Let's GET Wellington MOVING

Appendix L - Golden Mile Peer Reviews

Golden Mile Business Case
Peer Review Report
SSBC Review

Project: Lets Get Wellington Moving: Golden Mile
Report title: Peer Review Report: SSBC Peer Review
Document reference: J001806 LGWM Peer Review
Date: 13 September 2021

Figure 3: Courtenay Place/ Taranaki Street give way parameters

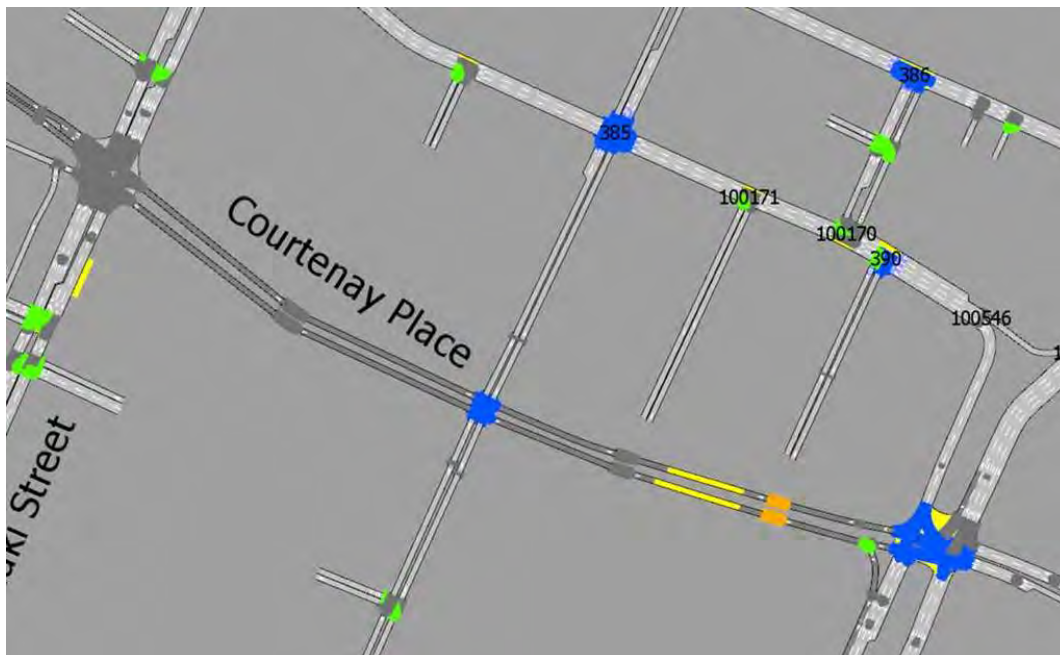
We note the model seemed to have excluded static turn type parameters along Courtenay Place and near Thorndon Quay. The signalised movements should have these coded, which are shown as Blue at the other signals within CBD, give way movements should be shown in Green, see Figure 3.

The response agreed that the turn types are missing at these two locations. However the response noted that:

- ◆ The missing give way turn from Thorndon Quay is for buses only, which are on predetermined routes
- ◆ The Courtenay Place/Taranaki Street intersection does have the signal turn penalty functions all set, so the correct capacity reductions will be applied, with the second user cost field only used as a trigger to reset these.

3.1 Moderate Concern – Pedestrian/cyclist conflicts

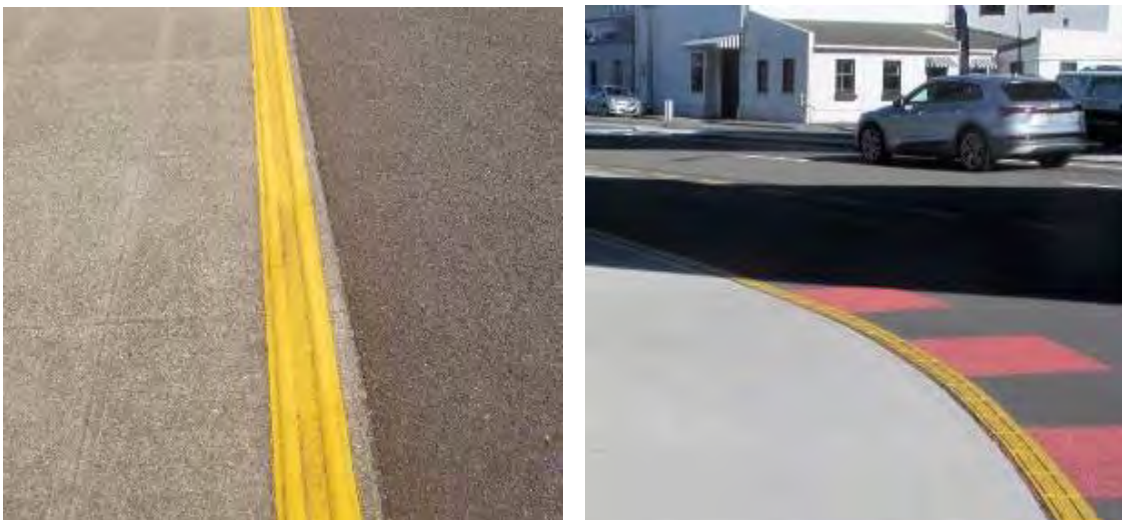
Probability of Crash Occurring – Common
 Likelihood of Serious/Fatal Injury – Unlikely
Outcome – Moderate

The contiguous nature of the separate pedestrian and cyclist areas on Lambton Quay and Courtenay Place will generate the risk of pedestrians being in the cyclist areas and coming into conflict with cyclists. Different and contrasting surfacing can help differentiate the pedestrian and cyclist areas, but experience is that this textural and/or colour differentiation can be too subtle for many pedestrians if it is the sole means of defining the two areas.

Designer Response:	Agreed – the cycle path and transitions into shared use or other areas will be developed further in developed design. The design will include, where possible, clear separation between users, managed crossings and other design features to manage the speed and conflict of cyclists and pedestrians.
Safety Engineer:	Agree – the use of raised tactile line marking can cause a tripping hazard. Designer/SAT team have to assess the effectiveness of this delineation for the Visually Impaired pedestrians. Another option is to allow pedestrians to use the whole area while confining cyclists to the defined paths.
Client Decision:	
Action Taken:

Figure 7: Bowen St/Whitmore St/Lambton Quay intersection

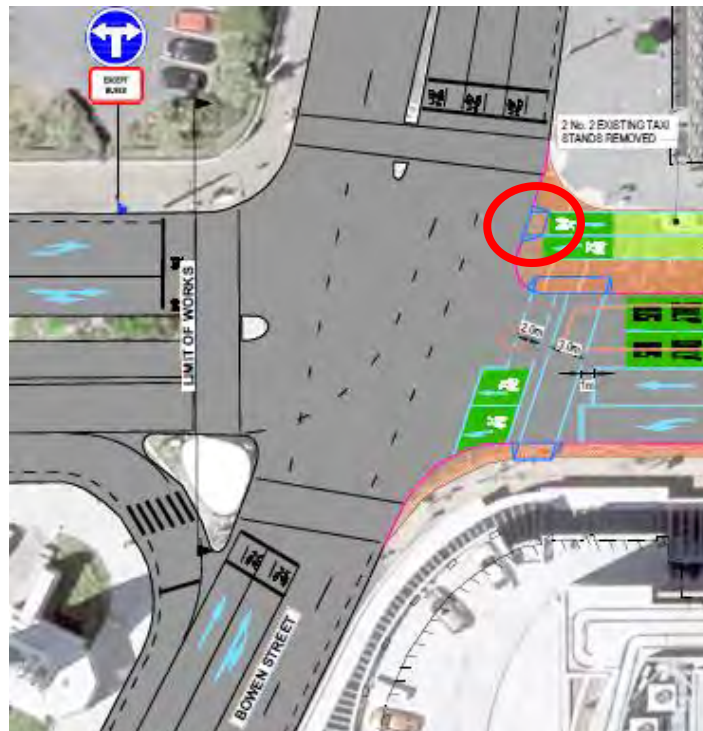
For cyclists wanting to move to/from the Lambton Quay cycle path, the layout at the intersection as shown in **Figure 7** (from drawing G020), does not provide safe access for all desired movements. For example, cyclists leaving the path are directed to the left to cycle boxes that enable on-road movement to Bowen Street or continuing along Lambton Quay. No safe provision is made for cyclists wanting to access Whitmore Street. Conversely, on-road cyclists wanting to access the cycle path from Bowen Street in particular are unlikely to use the ramp shown (circled), but take a more direct route that takes them through pedestrian areas.

The primary safety concern relates to a cyclist being hit by a vehicle within the intersection.

- a. Ensure that at the Bowen St/Whitmore St/Lambton Quay intersection the primary cycle network is clearly signed.
- b. Modify the intersection design to provide safe access to/from the cycle path for all potential movements.

Figure 8: Bus stop and crossing area south of Whitmore Street

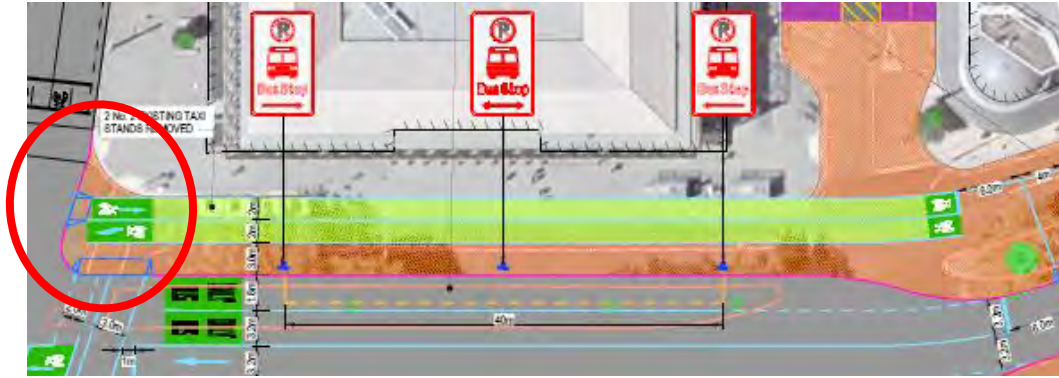
Following on from 4.1 above, the pedestrian/cycle area on the eastern side of Lambton Quay south of Whitmore Street will generate a lot of interaction between cyclists, pedestrians and waiting bus passengers, compounded by the presence of bus shelters. The cycle path is shown on drawing G022 bisecting the existing footpath and the extended footpath (see to **Figure 8**).

At the corner of Whitmore Street and Lambton Quay, there will be additional cycle/pedestrian conflict areas as people move to the different crossing points (circled).

In cognizance of the level of interaction in this area, consideration should be given to designating this area (Whitmore St to Ballance St) a shared use area and starting the cycle path at Ballance Street.

The alternative would be to highlight the cycle path and to encourage cyclists to take care in the vicinity of the bus stop. This could necessitate additional markings and signage in the cycle path. However, this could also result in pedestrians suddenly appearing in the cycle path from behind bus shelters resulting in increased pedestrian – cyclist crashes as cyclists would have insufficient time to react to avoid a crash.

Figure 9: Brandon Steet/Lambton Quay intersection

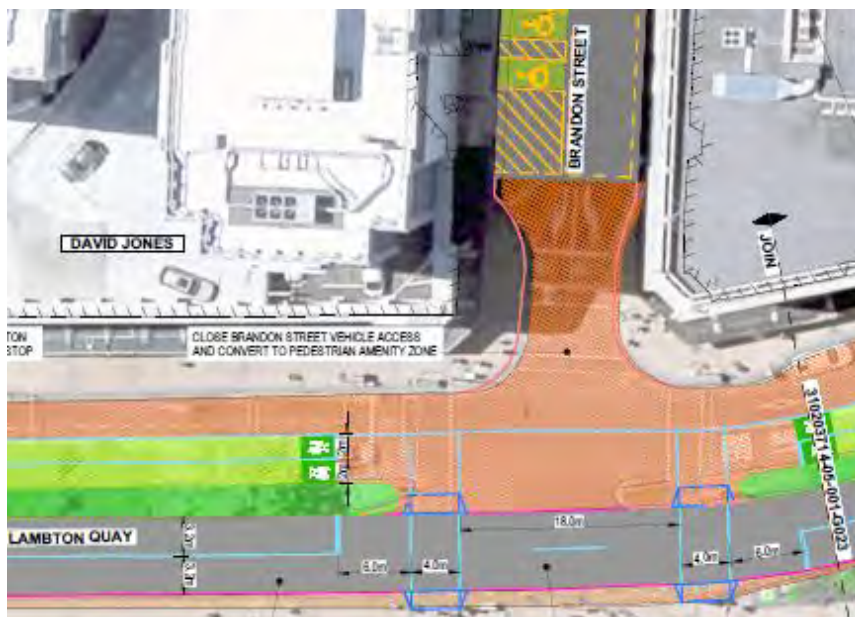
There are several bus routes that use Brandon Street in the peak periods (6am-10am and 3pm-7pm) and exit onto Lambton Quay. The SAT was advised that these bus routes are likely to continue in this location for a period of time after the initial implementation of the Golden Mile improvements. This means that the closure of Brandon Street at Lambton Quay, as shown in drawing G022 (see **Figure 9**), will not initially be possible.

This will generate a potential safety issue at the Brandon Street/Lambton Quay interface. Given the very wide pedestrian/cyclist area, there is a high risk that pedestrians and cyclists will not be expecting or be aware of buses exiting Brandon Street onto Lambton Quay, even if signal controlled. The safety issue is exacerbated by the fact that buses will only be exiting at certain times of the day. It will be important that the bus route through the expanded pedestrian area is appropriately managed and that other vehicles are prohibited from accessing Lambton Quay. To this end, it may pay for the bus route through the widened pedestrian/cyclist area to be carriageway with kerb and channel.

Whilst the bus exit onto Lambton Quay can be readily signalised, it will be difficult to clearly signalise the approx. 12m wide combined pedestrian/cyclist area.

Figure 20: Significant stormwater sump at bottom of sag curve in Manners Street

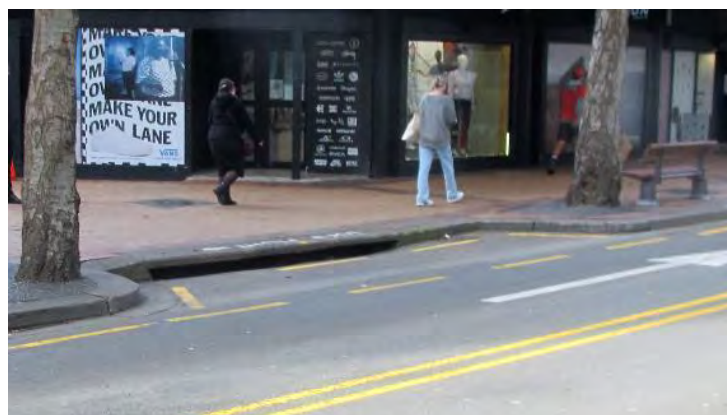
On drawing G420, some footpath widening is shown on the northern side of Manners Street at the location of a significant stormwater sump located at the bottom of a sag curve (see **Figure 19**). Eliminating the recess at the sump could lead to excess surface water on the carriageway at this location (see **Figure 20**).

The safety concern is that excessive surface water could lead to pedestrians being sprayed by passing buses and making unexpected movements to avoid being splashed with the potential of injuring themselves.

Figure 21: Unnecessary limit line on Manners Street

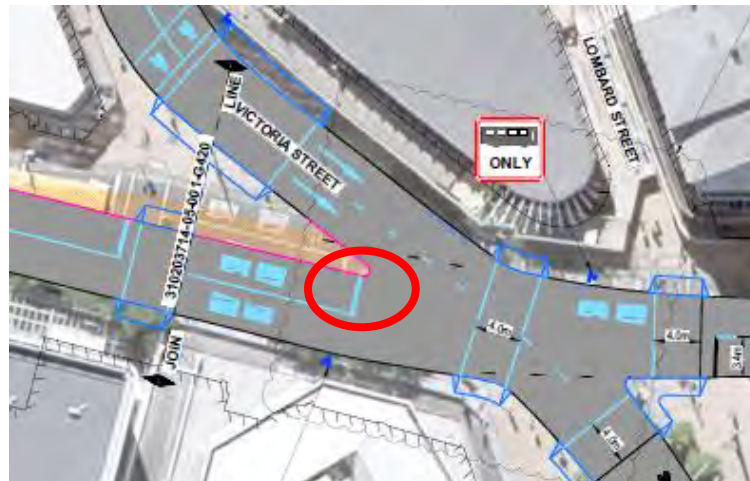
On drawing G422, an additional limit line is shown eastbound on Manners Street at Victoria Street, but there are to be no traffic signals at this point (see **Figure 21**). The limit line should be removed.

Designer Response:	Agreed. This limit line will be removed.
Safety Engineer:	Disagree. This limit line has a signal detector loop within the lane to show buses and other right turning vehicles (during night time and weekends) when stuck within the intersection where they need to wait in order to be detected so that when the next "Manners St" phase begins, there will be a late start for westbound buses. This limit line can be removed if this right turning vehicles can be catered for in the revised signal phasing. Designer Response - noted. Intersection configuration and phasing has yet to be completed, we will review this limit line once we have further information on final phasing.
Client Decision:

Figures 27 and 28: Building and street furniture obscure intervisibility between path users

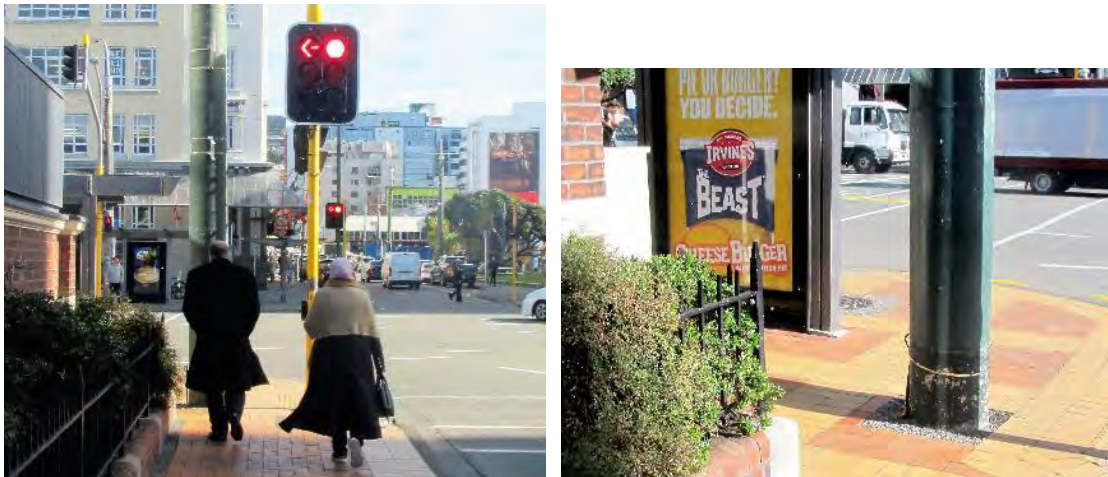
There is the potential for appreciable cyclist-pedestrian conflict at the south-eastern corner of the Courtenay Place/Taranaki Street intersection due to the corner of the former toilets, now pizza shop, building concealing cyclists from pedestrians and vice versa (see **Figures 27 and 28**). Note also that the existing street furniture exacerbates the problem.

Figure 32: Location of kerbside street furniture on southern side of Courtenay Place

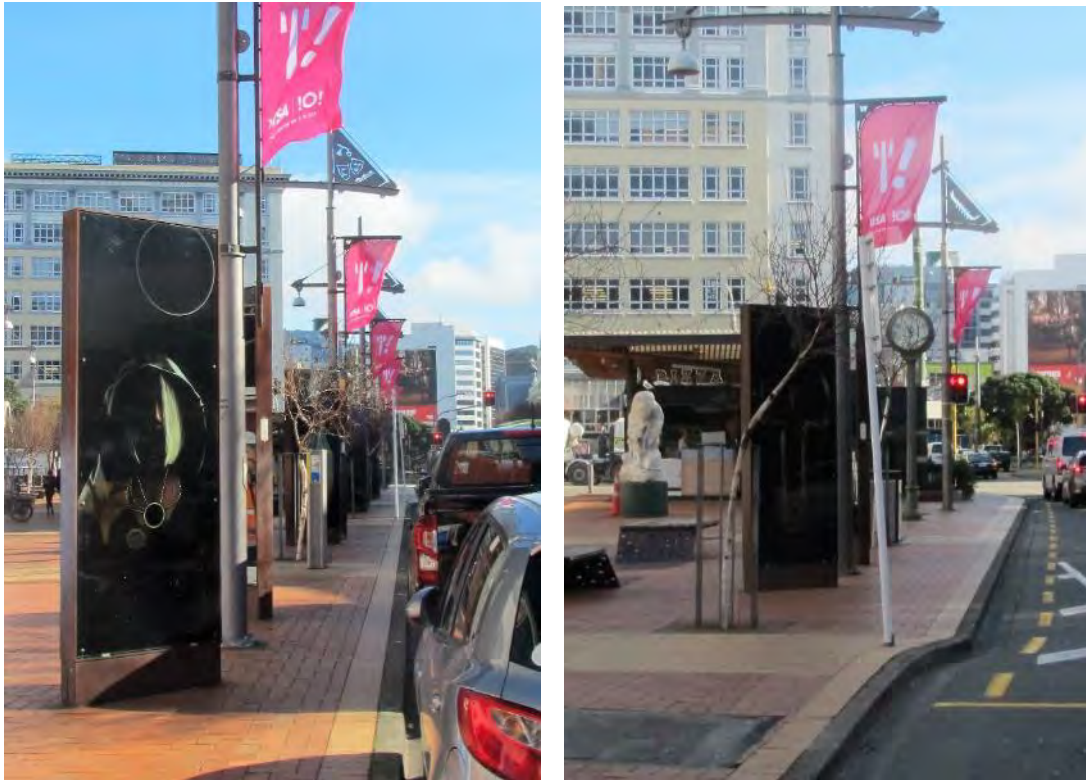
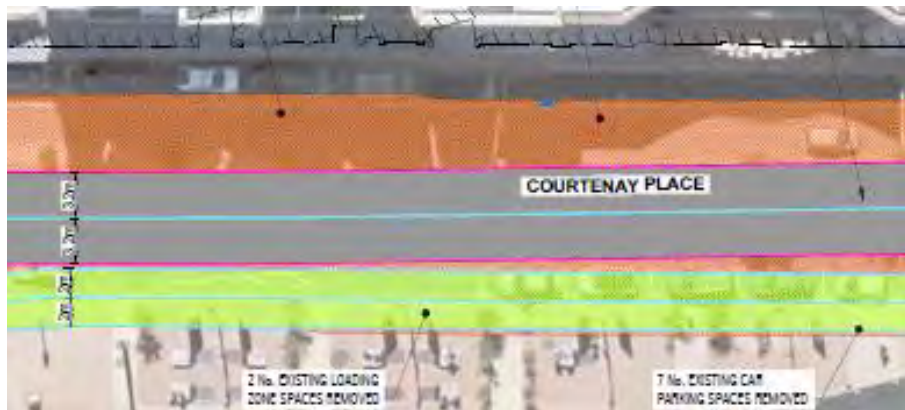
On the southern side of Courtenay Place at the large triangular pedestrian area leading up to Taranaki Street, there is currently a significant amount of kerbside street furniture (see **Figures 30 and 31**) located where the cycle path is shown on drawing G620 (see **Figure 32**).

It is not clear whether the proposed cycle path is not overlaid on the underlying aerial photo correctly or whether all the street furniture is to be relocated.

Designer Response:	All street furniture will be removed or relocated from the cycle path.
Safety Engineer:	Noted – street furniture locations should not obstruct the visibility between pedestrians (crossing Courtenay PI) and westbound cyclists in particular.
Client Decision:	
Action Taken:

Figure 34: No increase in footpath width west of Tory Street

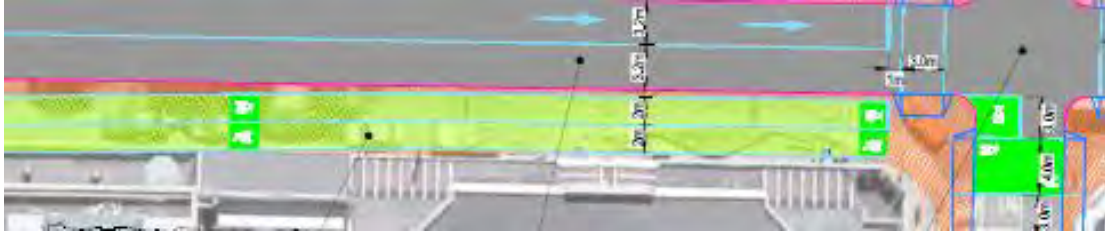
Between Tory Steet and the large triangular pedestrian area prior to Taranaki Street, there does not appear to be any increase in the width of the pedestrian area on the southern side of Courtenay Place whilst a 4m wide cycle path is to be provided (see extract from drawing G621 in **Figure 34**). Per the comment in section 7.3, it is not clear whether the proposed cycle path is not overlaid on the underlying aerial photo correctly or whether the existing footpath is to remain as is. This latter situation could generate a higher risk of pedestrian cyclist conflicts.

Designer Response:	This is a point of some debate and will be investigated in detail – the area in question must accommodate a number of competing uses and will change according to time of day. This issue will be resolved in developed design.
Safety Engineer:	Noted – Emphasis on pedestrians is important as Walking (pedestrian needs) has a higher priority in the Sustainable Transport Hierarchy than cycling in the design of this area.
Client Decision:	
Action Taken:

Figure 35: Footpath widening shown within existing footpath

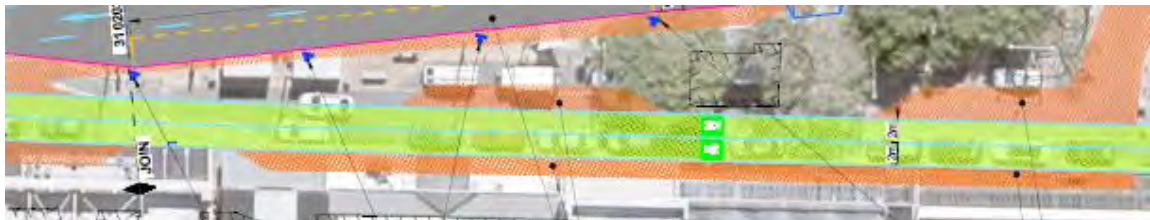
The same comment applies to the section on the southern side of Courtenay Place between Cambridge Terrace and Tory Street where footpath widening is shown on what is already footpath (see extract from drawing G622 in **Figure 35**), with the cycle path along the section of carriageway that is to be used by taxis and others at night-time. Again, it is not clear whether the proposed footpath widening and cycle path are not overlaid on the underlying aerial photo correctly or whether the existing footpath is to remain as is, with the cycle path utilising the area currently used for parking/servicing.

Figure 38: Courtenay Pl/ Cambridge Terr/ Kent Terr/ Majoribanks St intersection

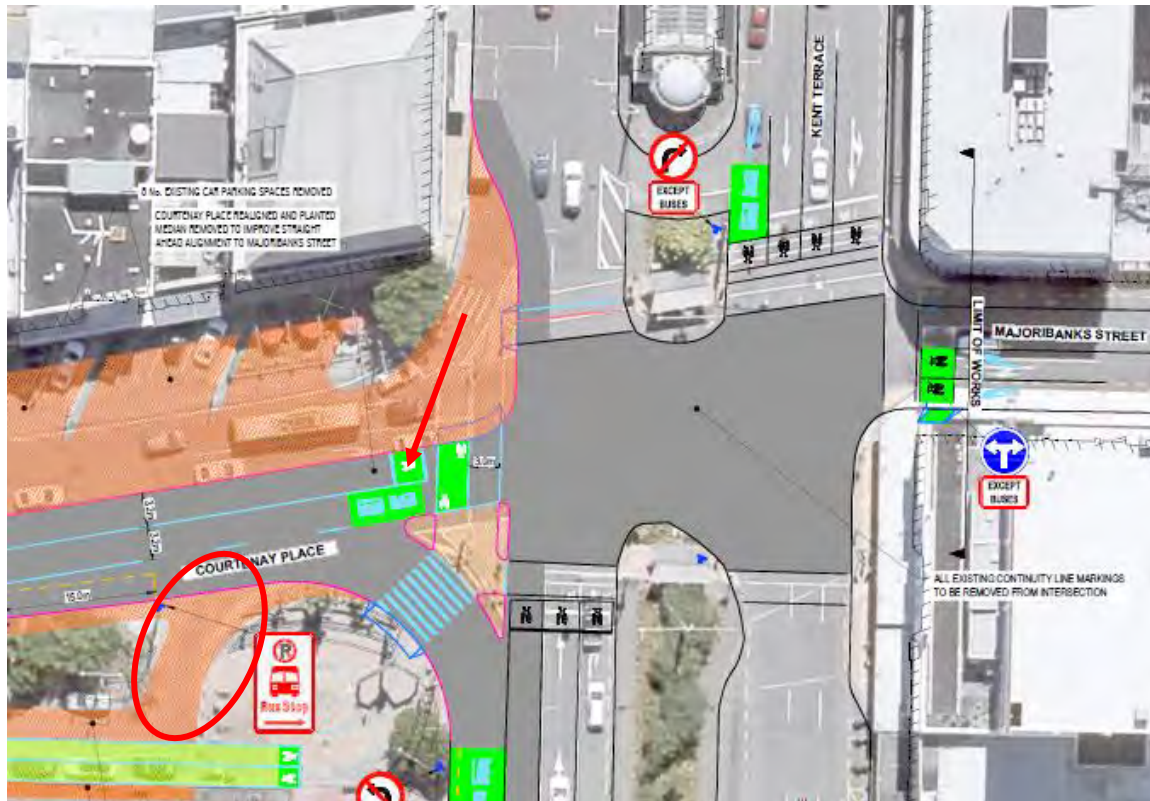
For cyclists wanting to move to/from the Courtenay Place cycle path, the layout at the intersection as shown in **Figure 38** (from drawing G622), does not provide safe and easy access for all desired movements. For example, on-road cyclists turning right from Kent Terrace or across from Majoribanks Road would be expected to use the triangular traffic island and the pedestrian zebra crossing, whereas the easiest and most direct route from all approaches would be to use the existing access in **Figure 39** (refer also to the red circle in **Figure 38**). This would avoid cyclist-pedestrian conflicts.

For cyclists leaving the cycle path, they have to somehow access the cycle box in Courtenay Place (arrowed) to then continue on-road or to use the various pedestrian facilities to access each road.

The primary safety concern relates to a cyclist being hit by a vehicle within the intersection.
